Our Ref: 24003 DA RFI Response 12 Murphy Street

**RFI CIVIL RESPONSE SUBMISSION
MCU - DWELLING HOUSES MCUC 2023_5563
12 MURPHY STREET, PORT DOUGLAS (L113 PTD2094)**

We refer to Douglas Shire Council's (Council) Information Request (IR) dated 1 February 2024.

HORZ 1:250 VERT 1:50

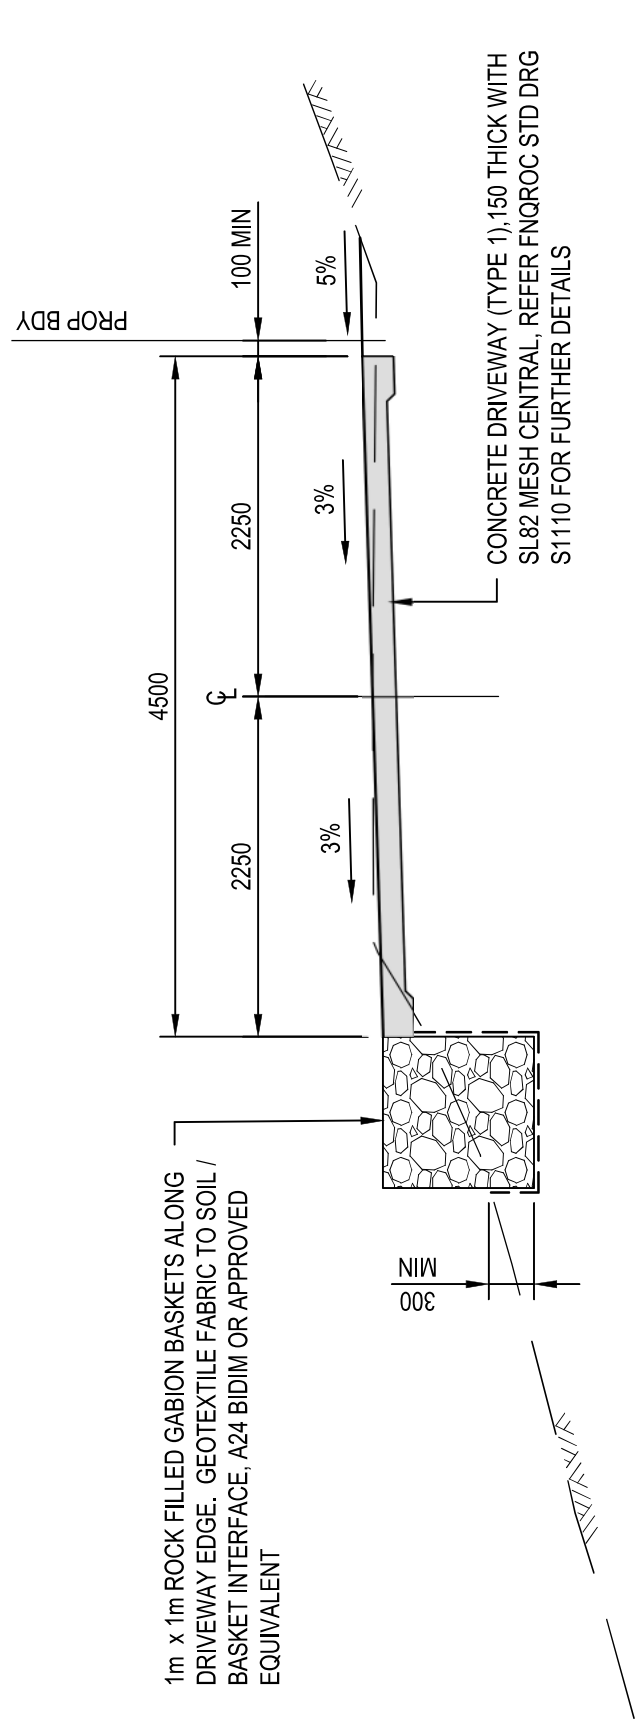
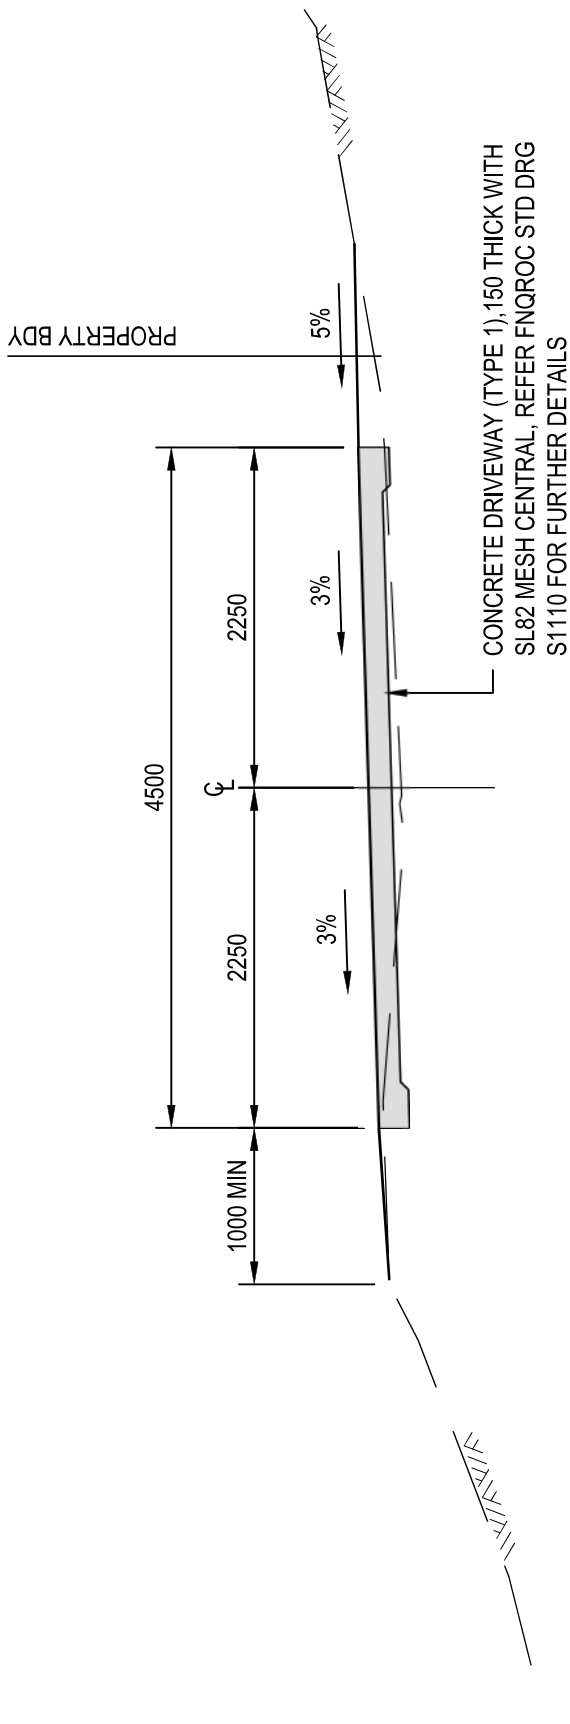
4. *Concern is raised regarding the requirement for a 1.8m retaining wall proposed in the Murphy Street road reserve shown on Balay Vandyke Drawing 7 of 14 (Site Plan- Revision F). Note, the proposed retaining wall also appears to be located near the top of an existing steep batter which may have stability implications for the road reserve. Note that a retaining wall in road reserve of this height is considered to be an unacceptable solution.*
Clarify the justification for raising the level of the shared access external to the site within the Murphy Street road reserve. Options to minimise the level change in Murphy Street are to be considered.
Provide a cross section through the proposed 1.8m retaining structure through to and including the Murphy Street road formation.
Advice Note: The contour information shown on the Site Plan appears to indicate the extent of the design creates a large flat driveway section within the site (adjacent the garage). The absence of grade transition in this area appear to reduce the length available for the driveway grading and appears to dictate the level at the interface with the shared access at Murphy Street (to achieve the proposed 1 in 4 gradient).

Officers note that it appears if part of the footprint of the flat portion of the internal driveway was utilised to manage the level transition, this may minimise the level change (and fill required) in Murphy Street. This would lower the height of the proposed retaining wall.

The proposed driveway has been regraded slightly to negate the need for any retaining within the road reserve. Sketch plans of the driveway with a long section and cross sections are included in **Appendices A and B**.

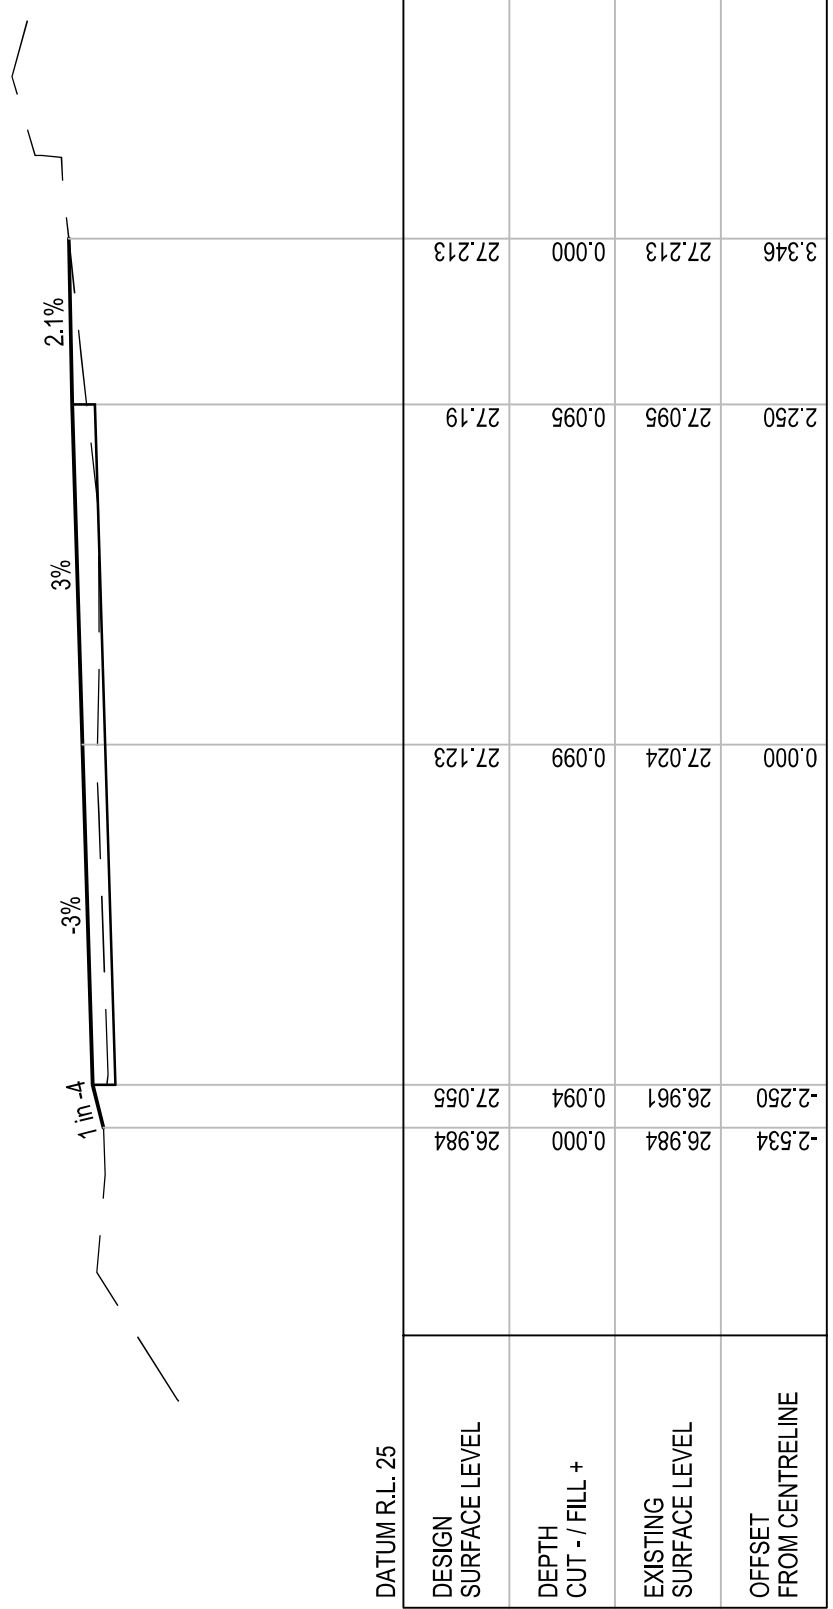
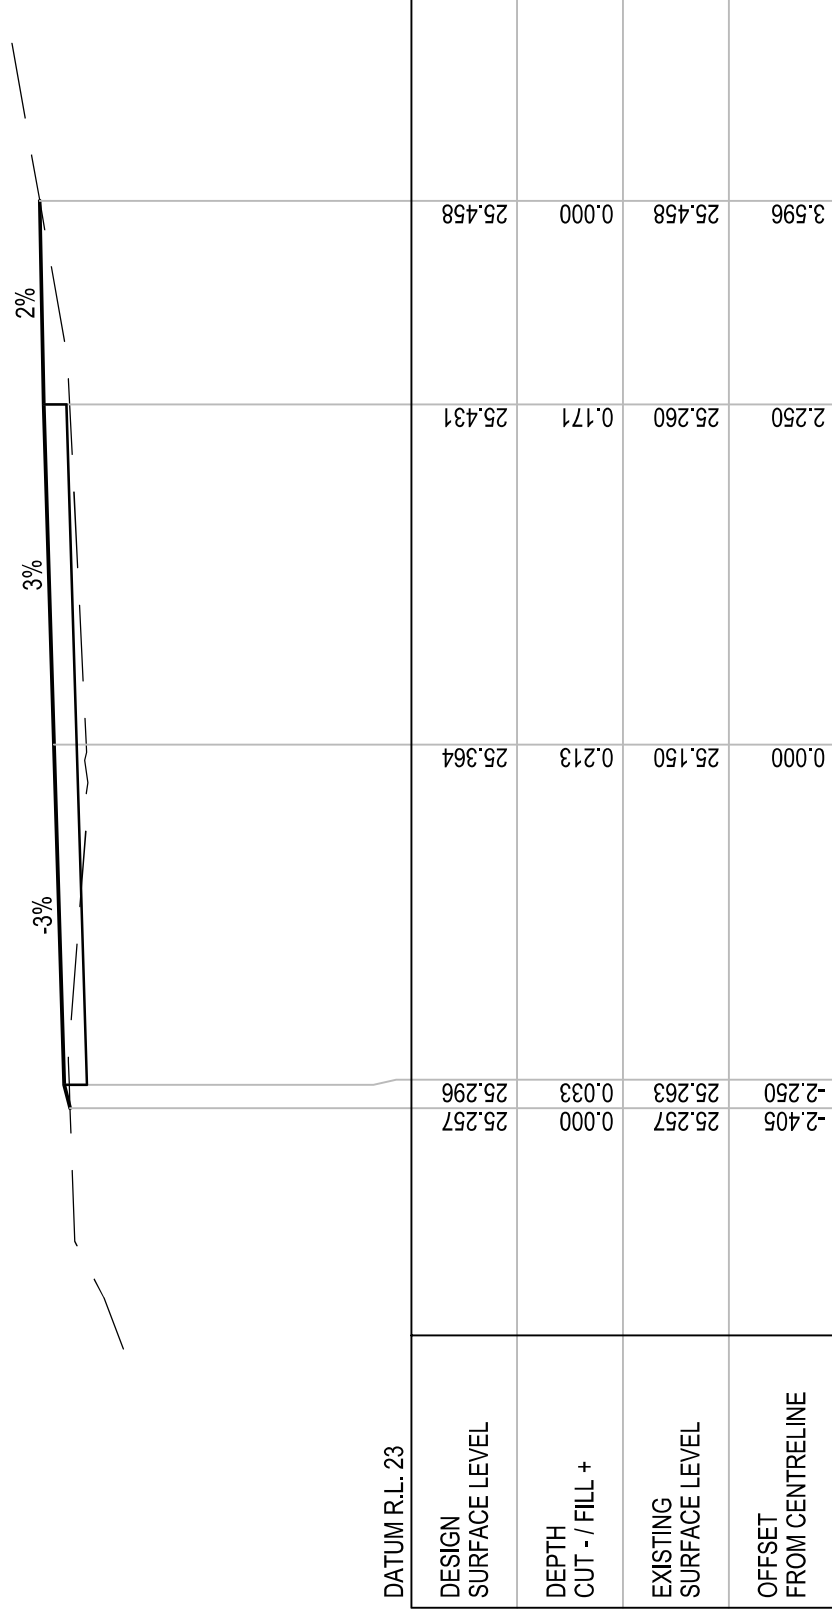
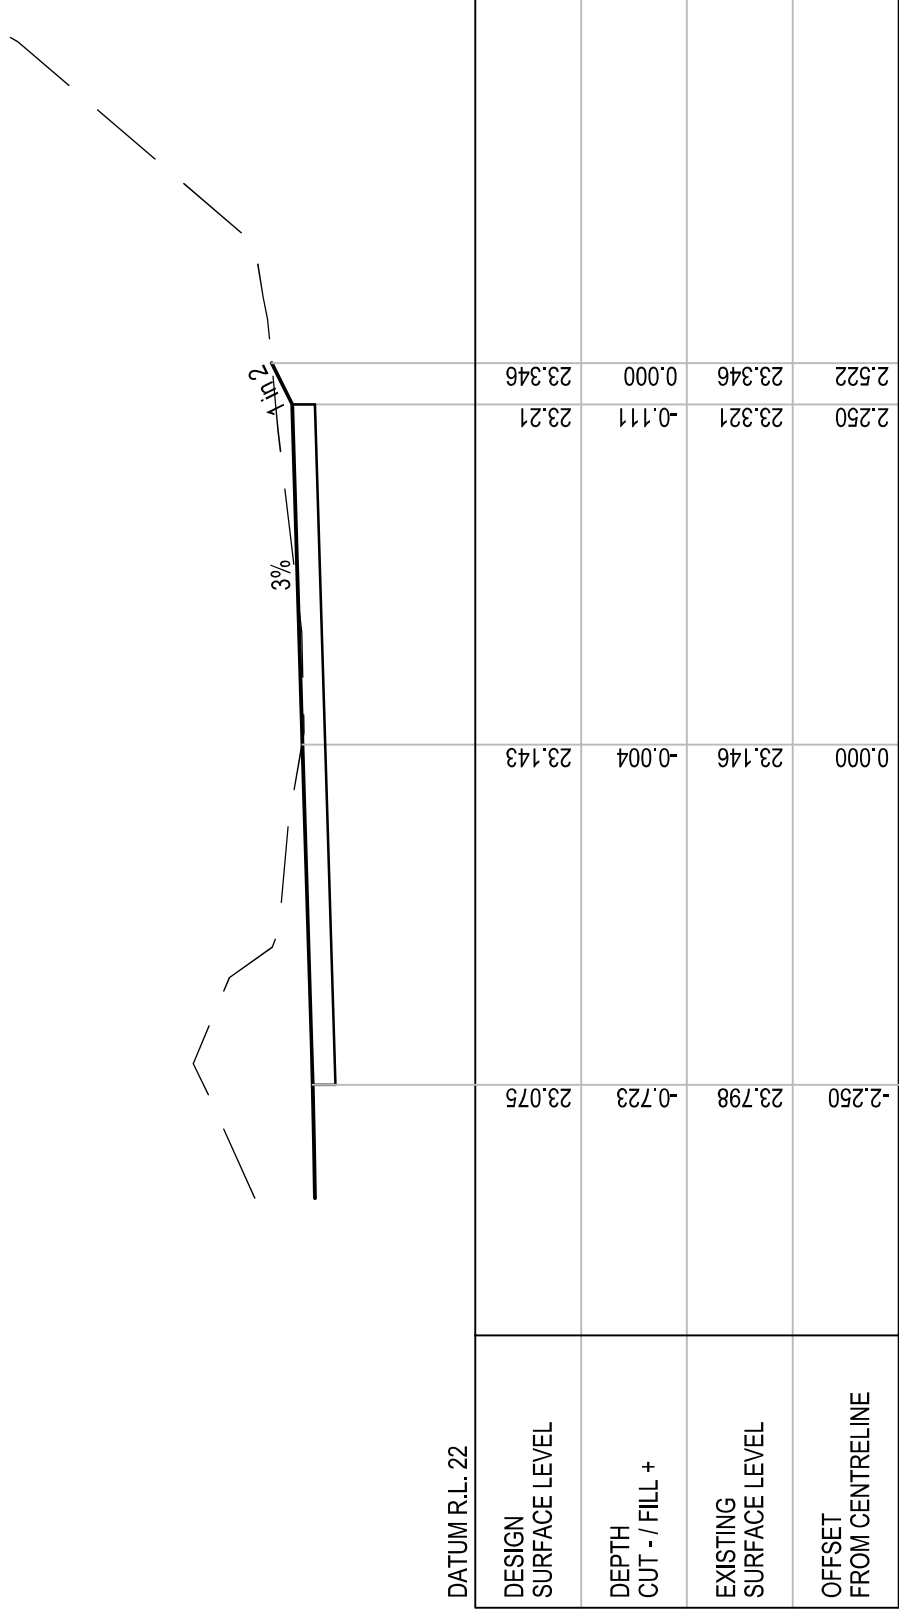
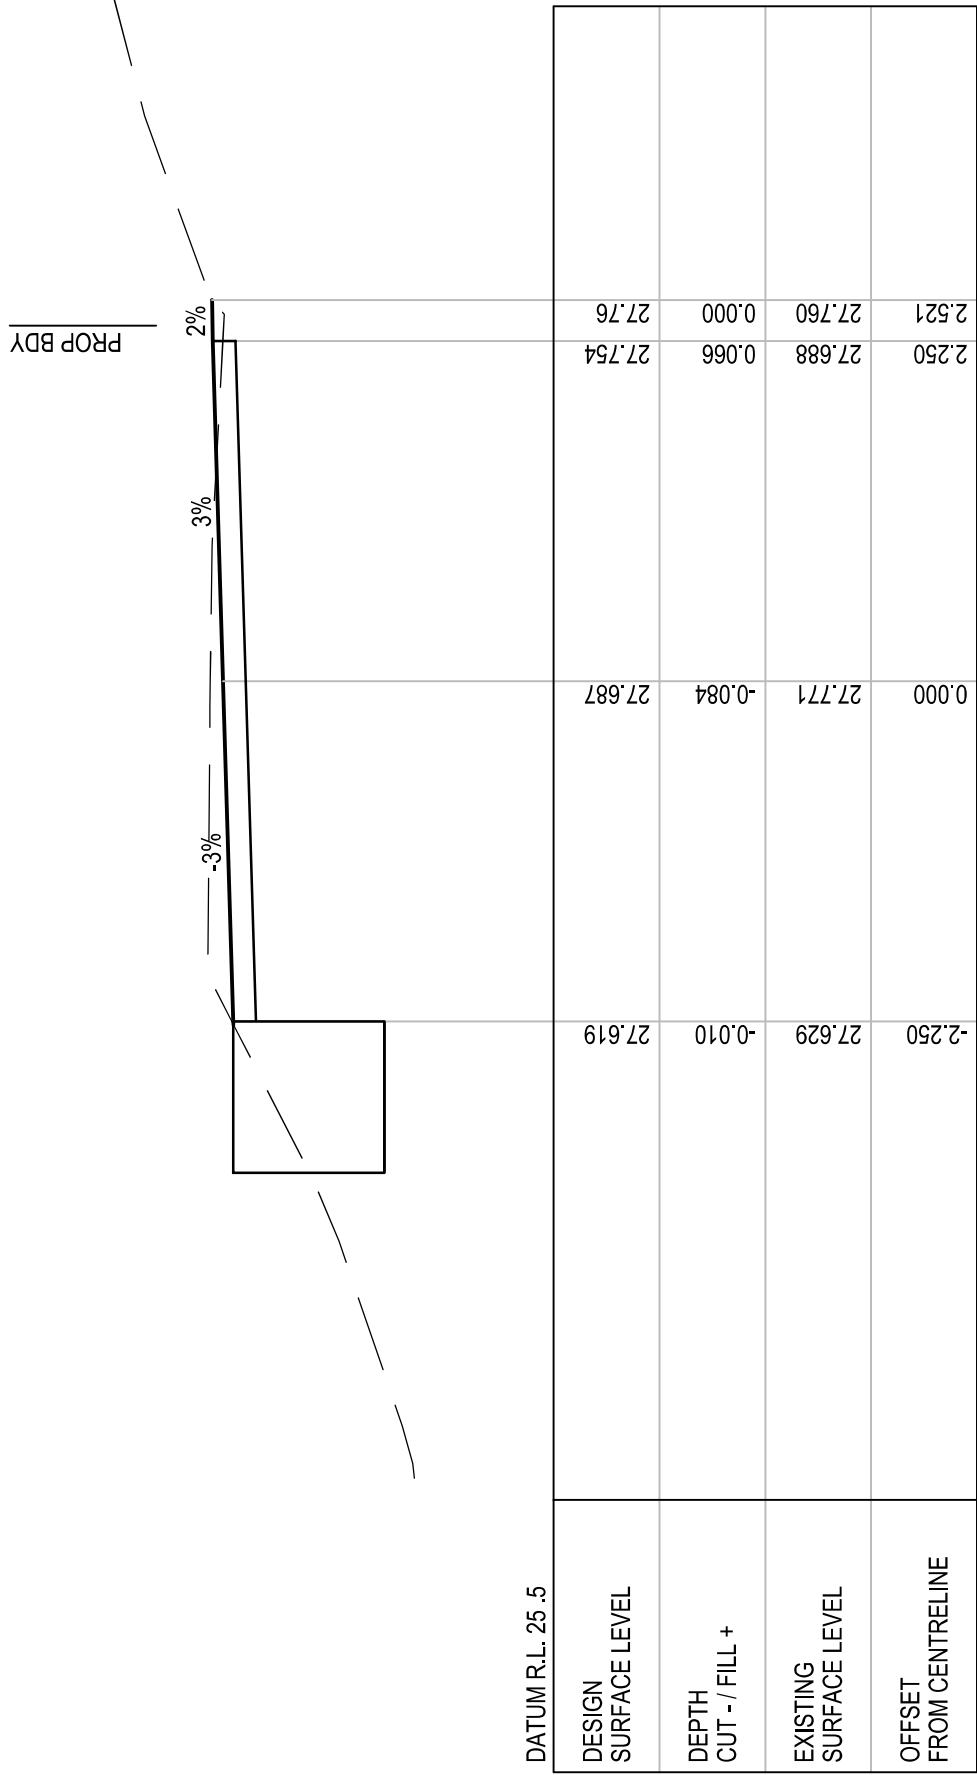
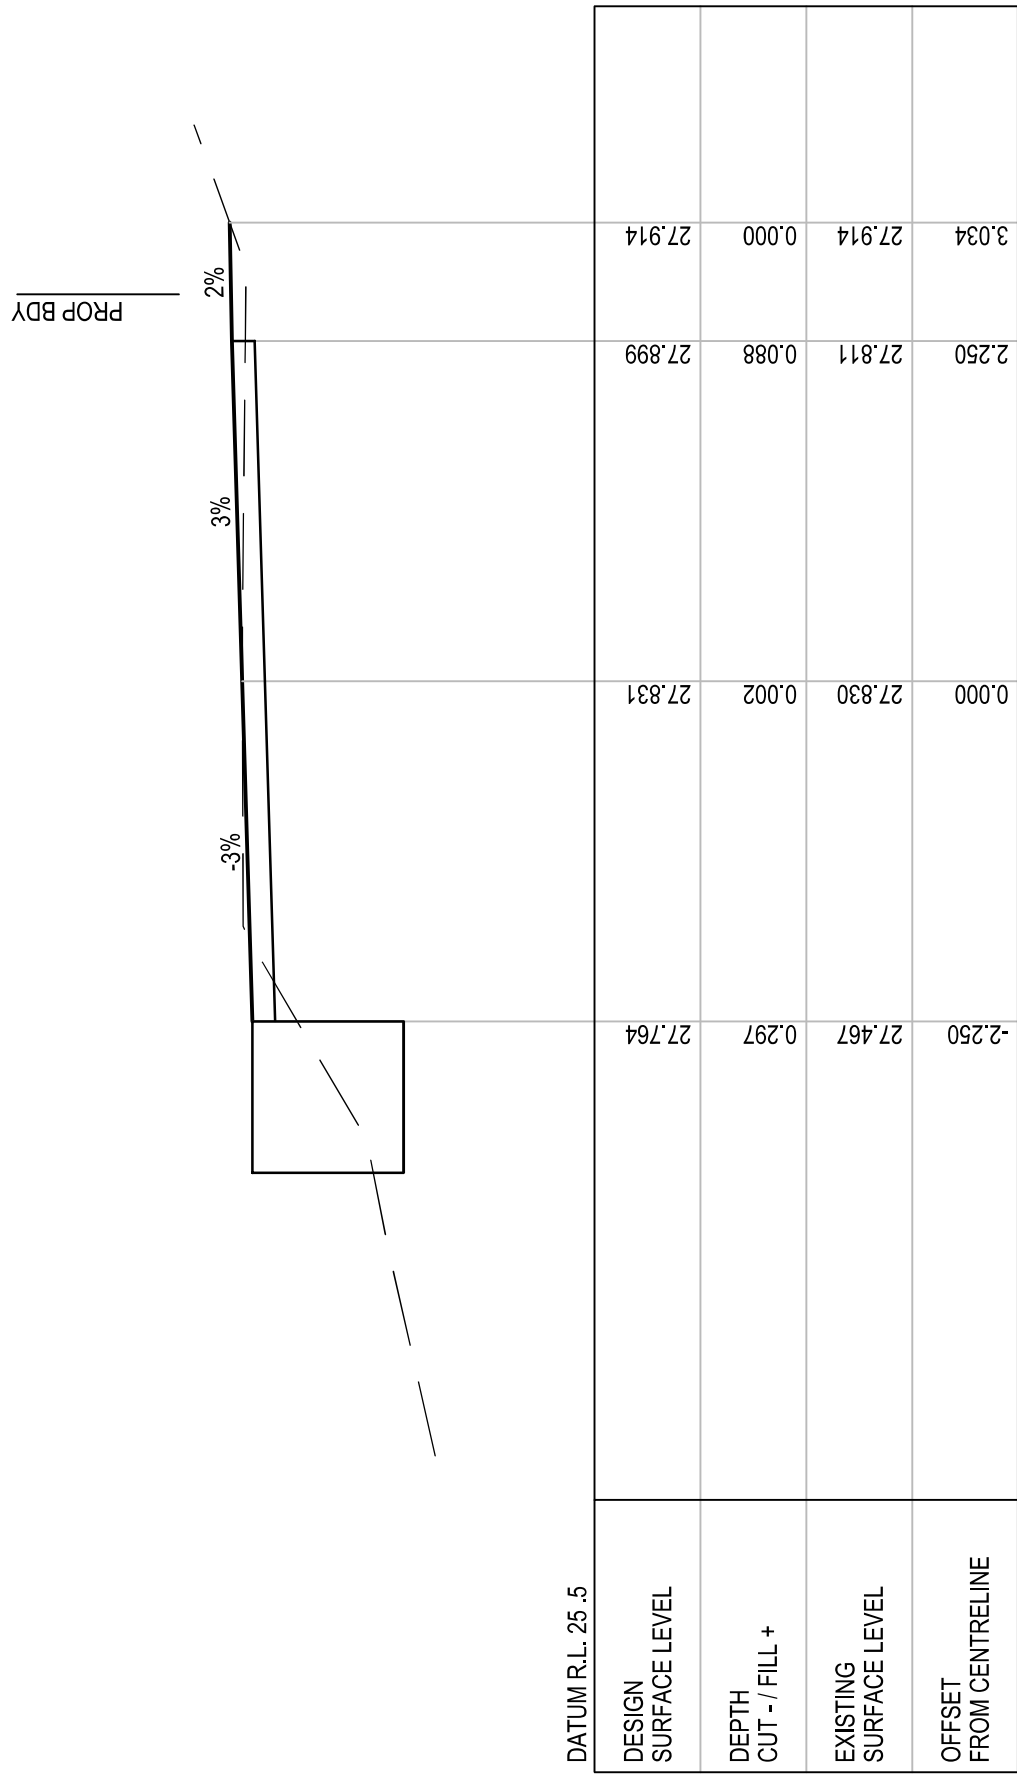
6. *Provide further information in the form of longitudinal and cross sections indicating the cut and fill required to construct the shared access in Murphy Street, and the internal driveway.*

Refer sketches provided in **Appendix B**.
